## HISTORIC AND DESIGN REVIEW COMMISSION

Agenda Item No: 24

**HDRC CASE NO:** 2015-331  
**ADDRESS:** 524 N PINE ST  
**LEGAL DESCRIPTION:** NCB 1370 BLK 2 LOT 3  
**ZONING:** RM4 H  
**CITY COUNCIL DIST.:** 2  
**DISTRICT:** Dignowity Hill Historic District  
**APPLICANT:** Ceaser Gonzalez  
**OWNER:** Ceaser Gonzalez

The applicant is requesting a Certificate of Appropriateness to amend the previously approved design to:

Historic and Design Review Commission  
Design Review Committee  
Report & Recommendation

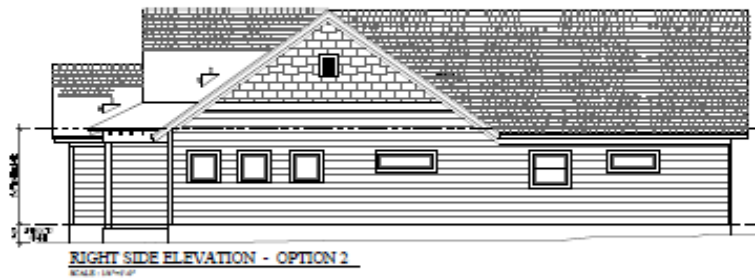
COMMENTS/CONCERNS: CB - intended to do two windows vs. one w/ shutter. MB - If you're doing wood, you should look at doing all wood. BF - having an aerial might help. Show context. MB - Street elevation is appropriate. Detail for return at gable. Bulk of house has lower ridge line. Visibility of side elevation? CB - side area is very exposed. MB - Multiplicity of window types, play w/ sizes to make it more consistent. Look at rhythm. Rear elevation isn't an issue. Not visible. Nicely done, good infill design.

COMMITTEE RECOMMENDATION: APPROVE ☒ DISAPPROVE ☐  
APPROVE WITH COMMENTS/STIPULATIONS:  
Show context. REVISE WINDOWS - SIDE
